Architectural Review Board

August 23, 2022 – 5:30 p.m.

III. Full Review of Items

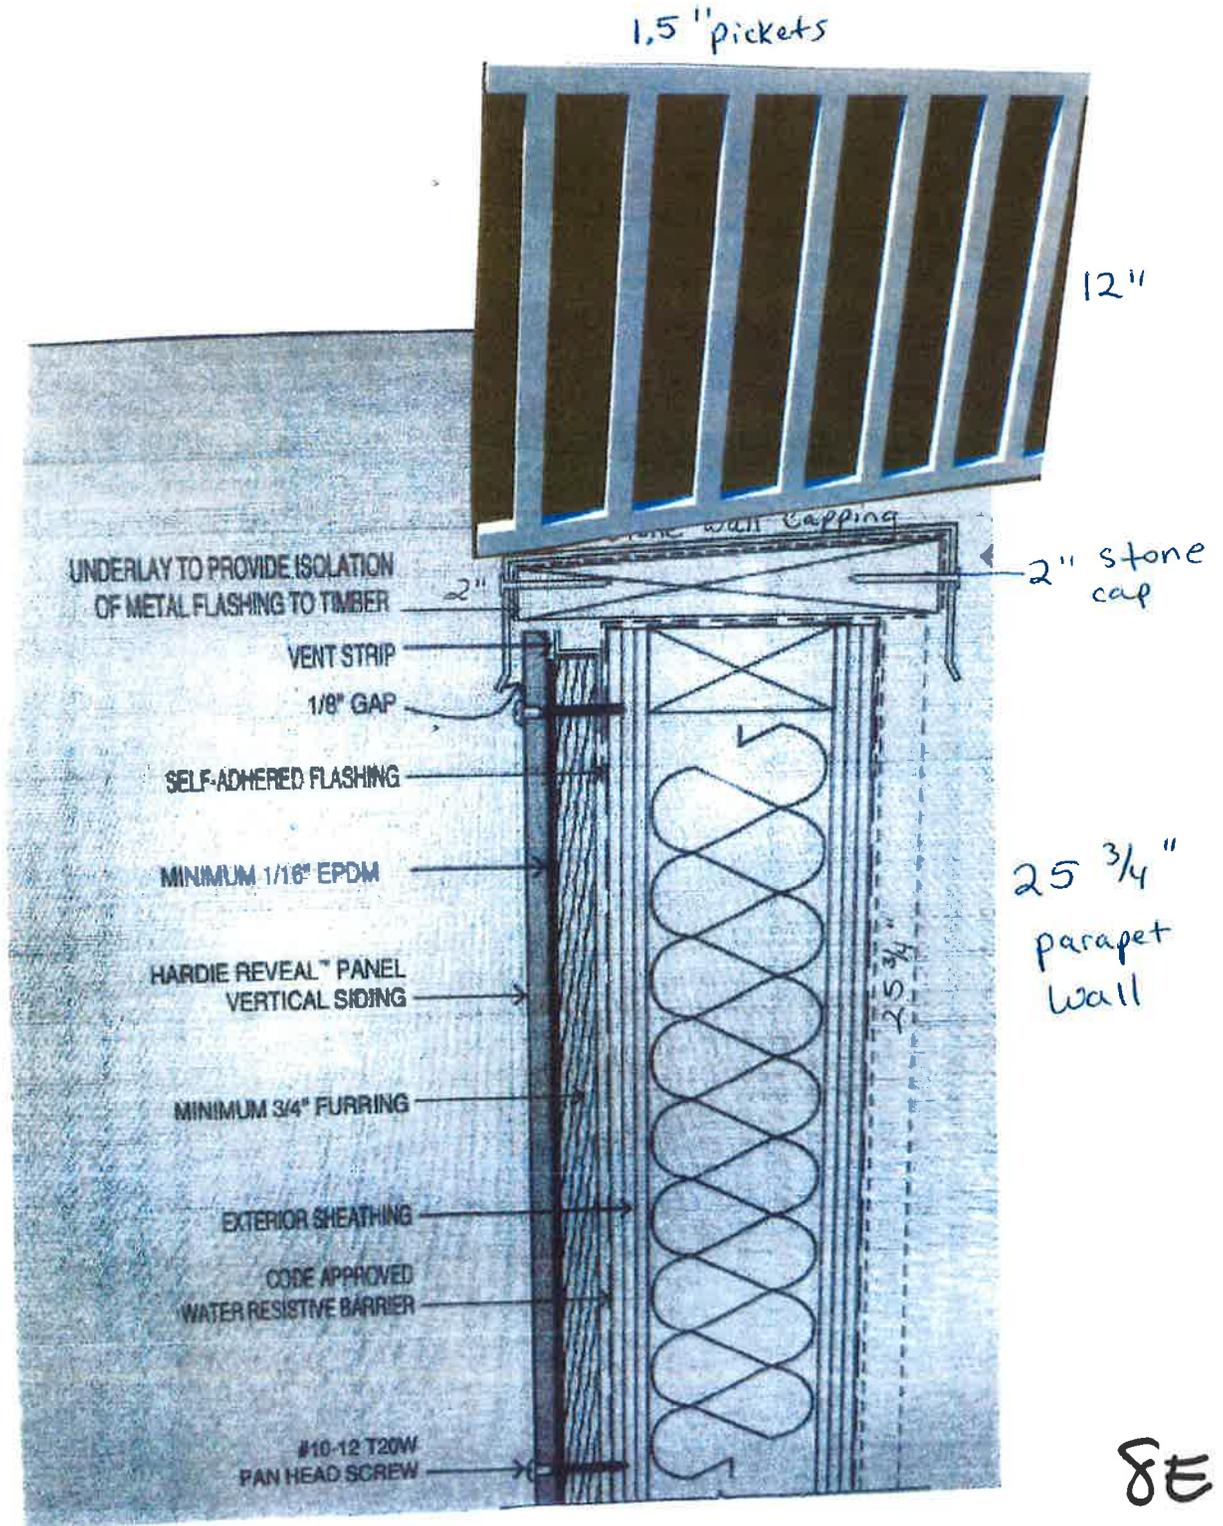
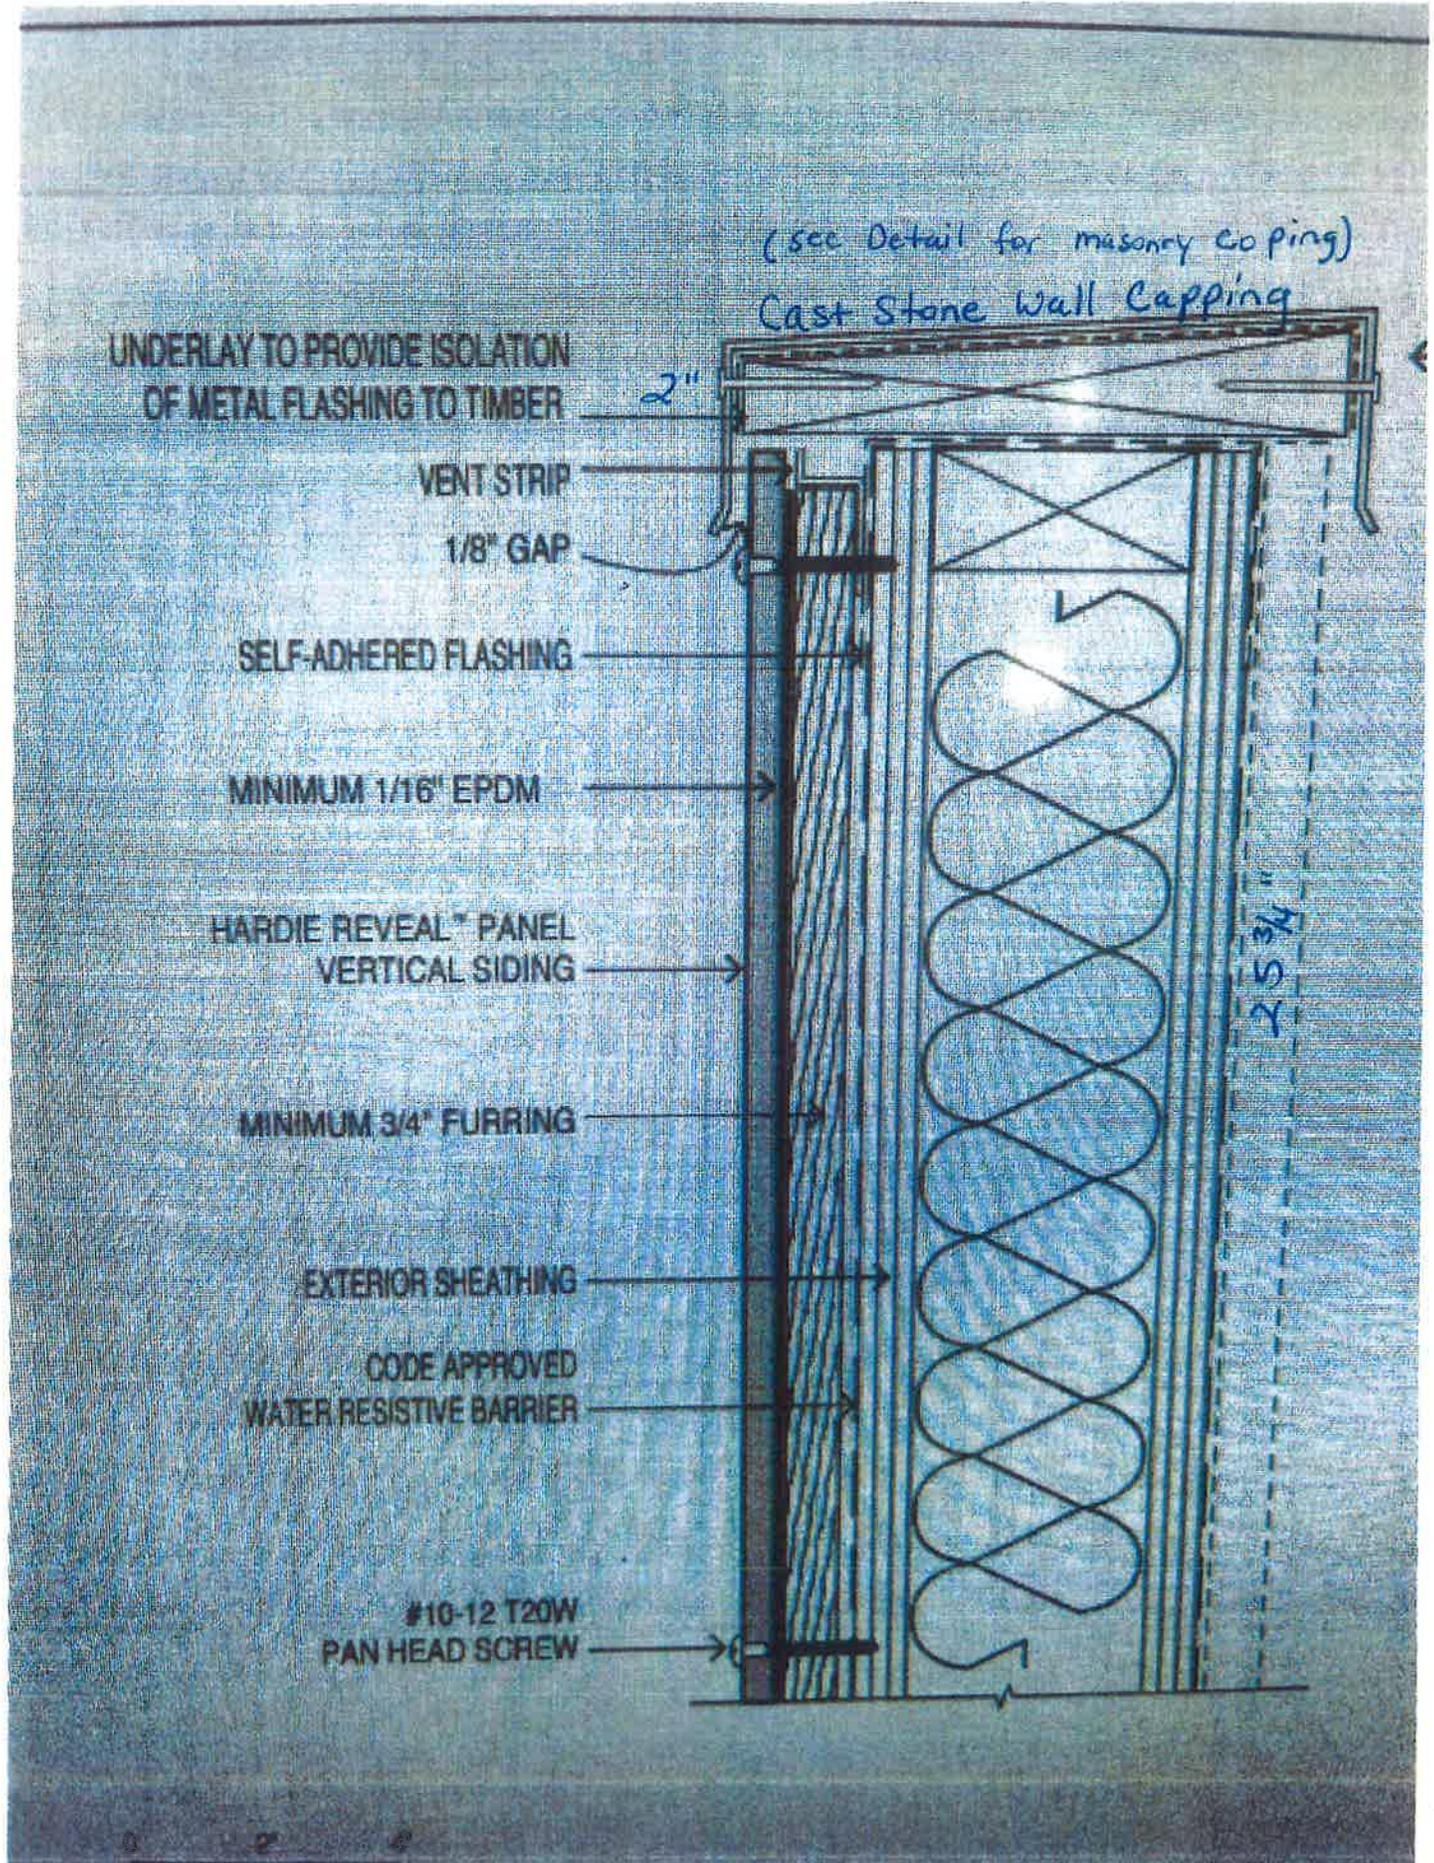
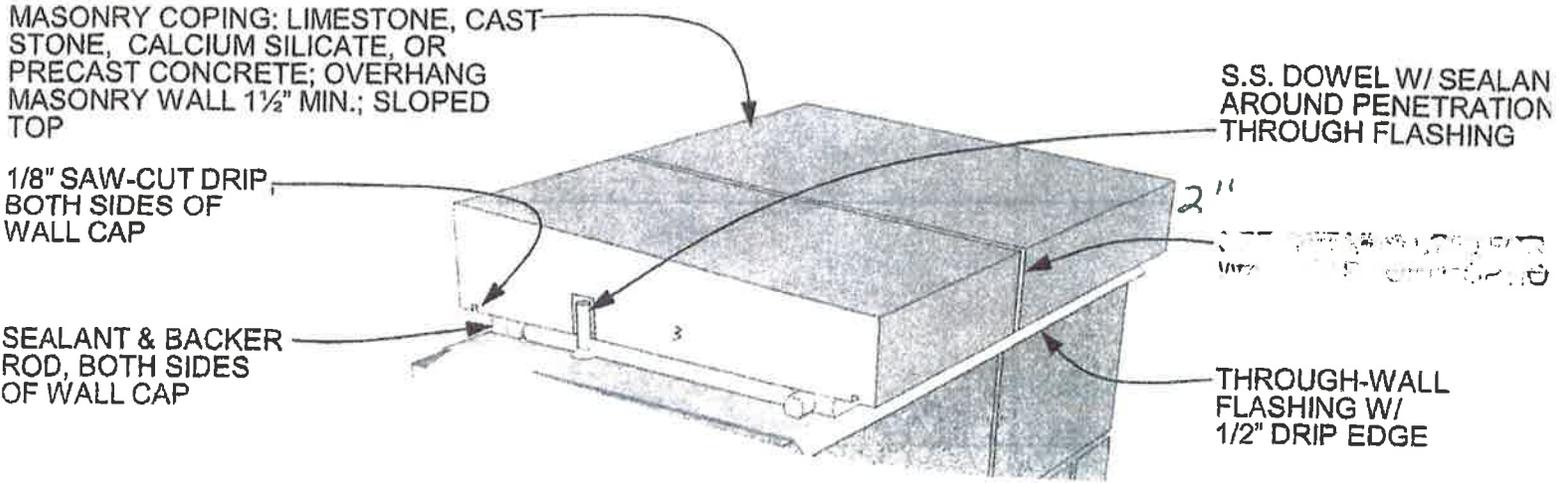
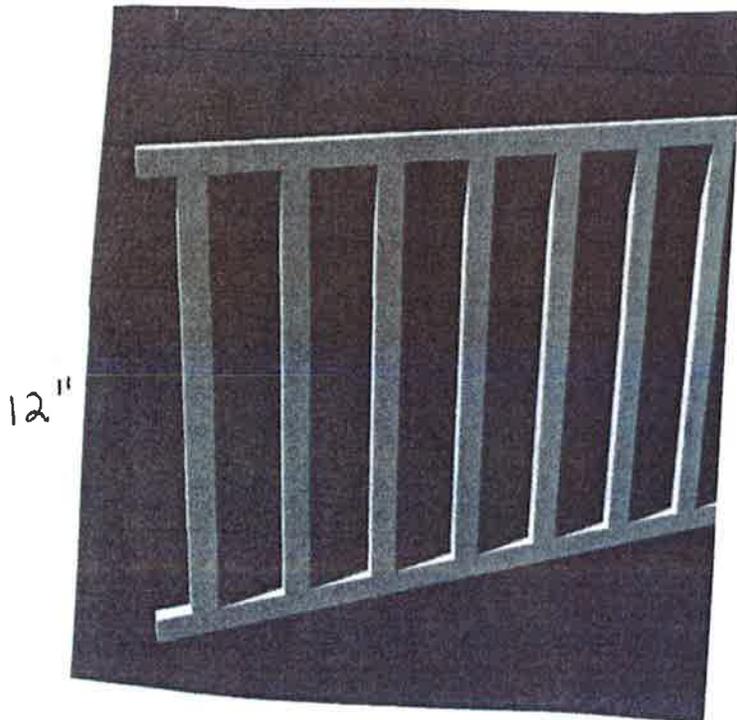
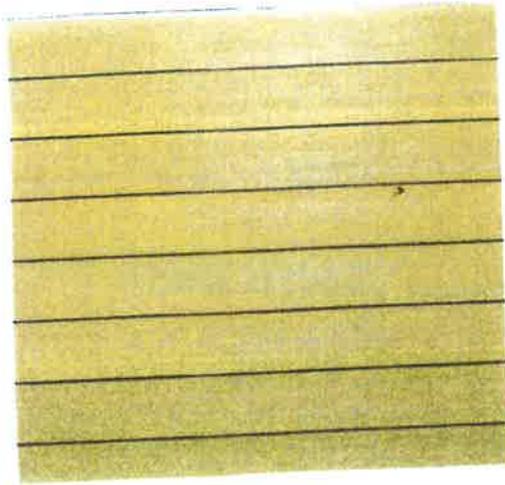
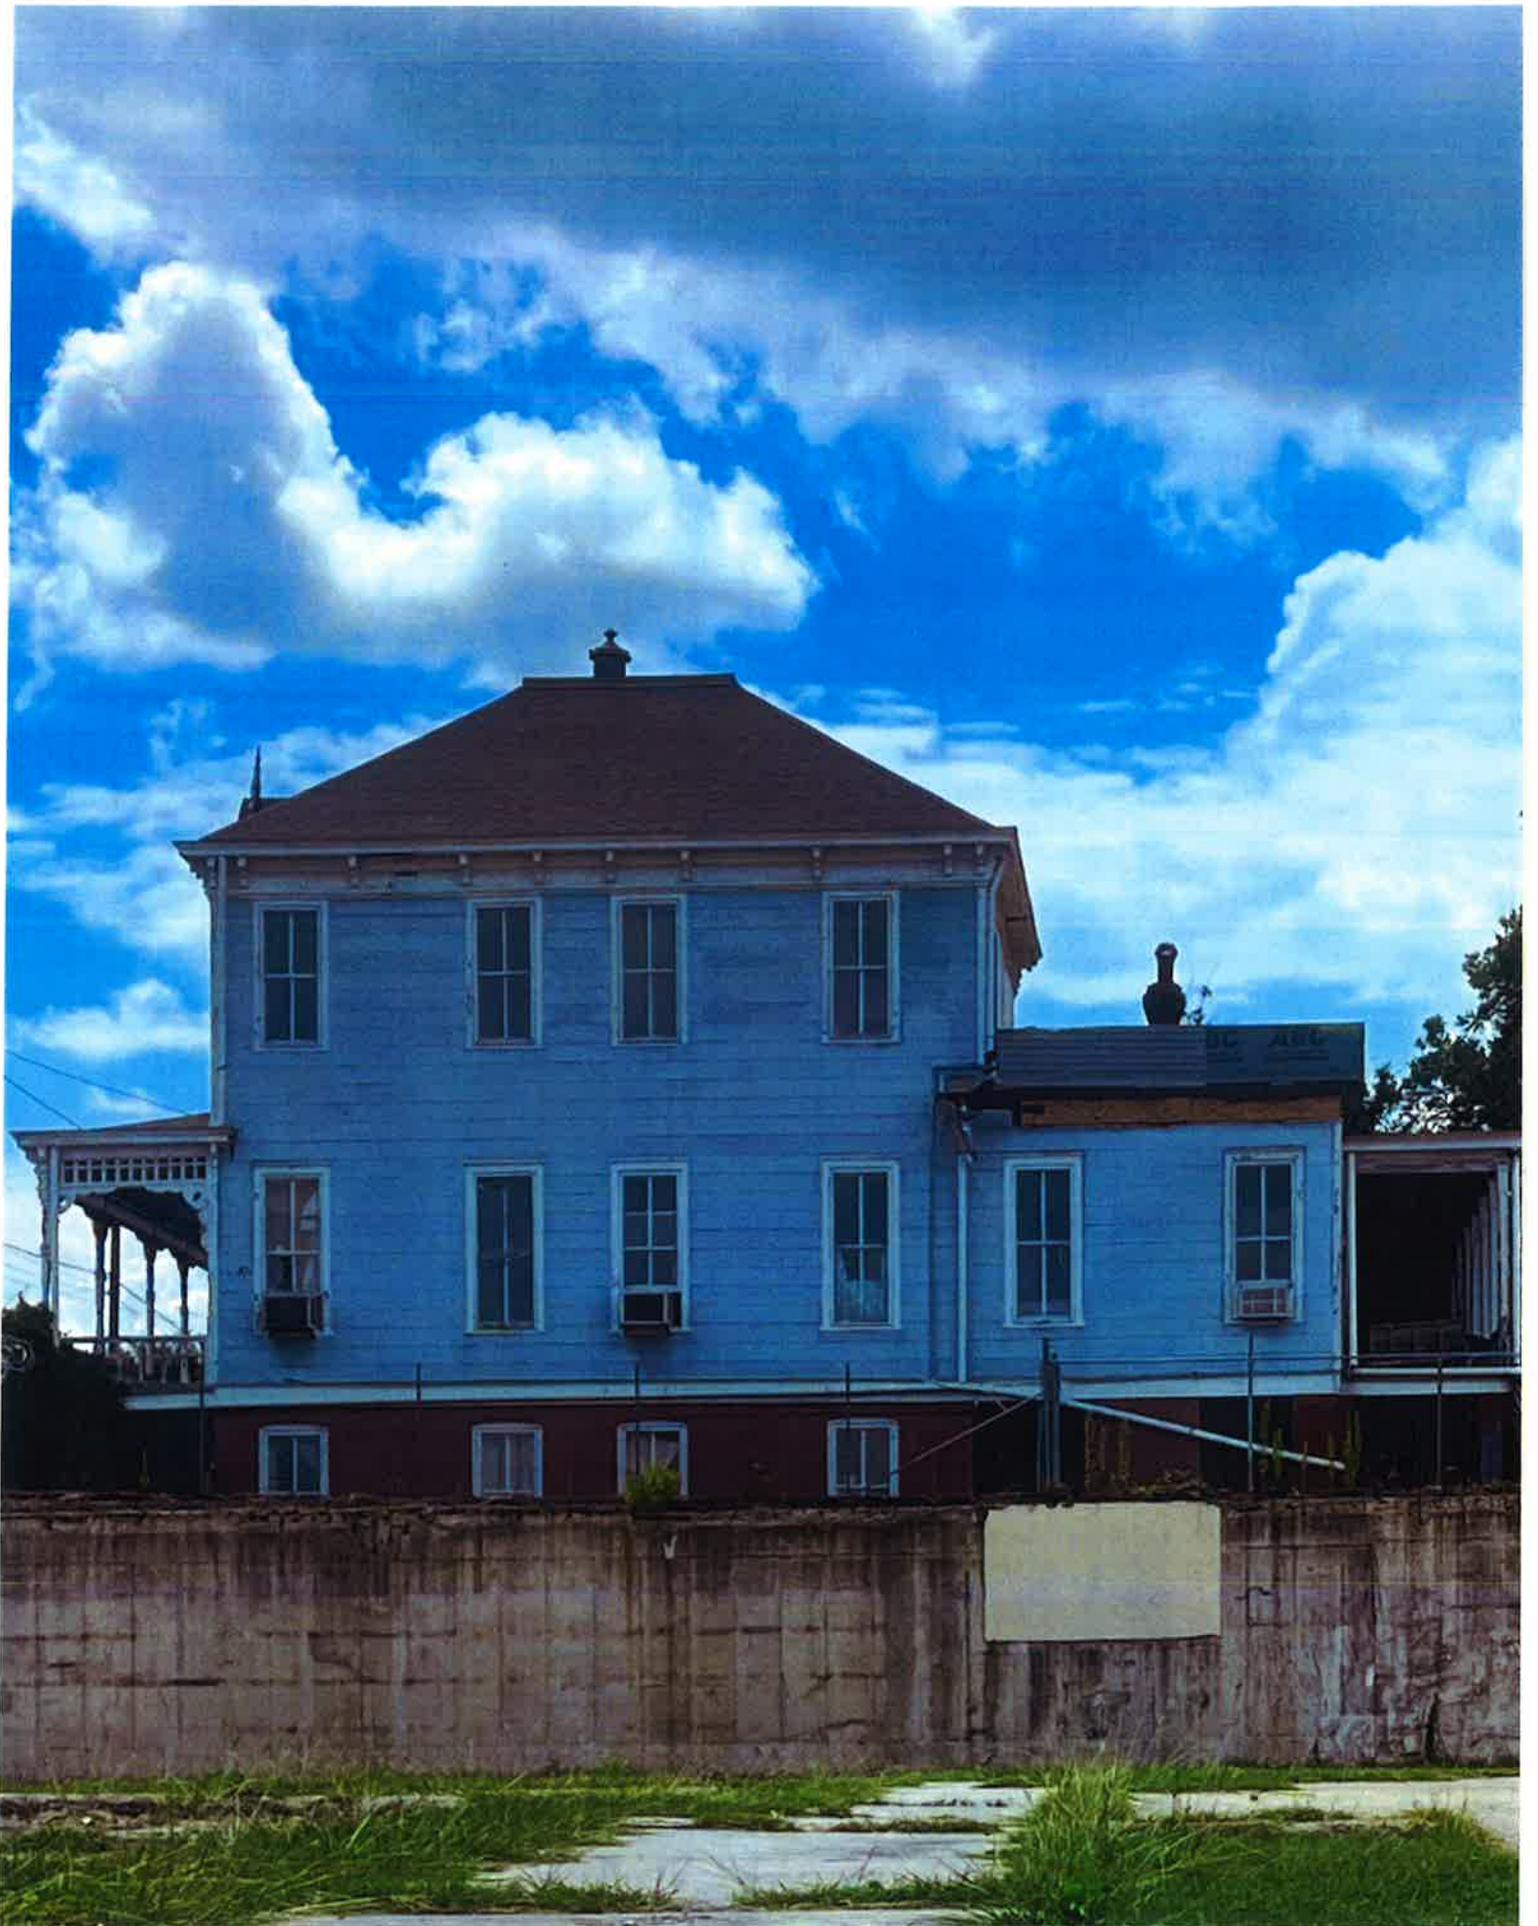
- As with any request for approval after the fact, the question the Board needs to ask itself is would we have approved this request had it been made prior to work being done.
- The Board needs to determine if the gable was a character defining feature of the structure. If it is, is this the solution you would have approved to address the water issue?
- The house is clad in cementitious shingle, the use of a cementitious product would be consistent with the historic cladding.
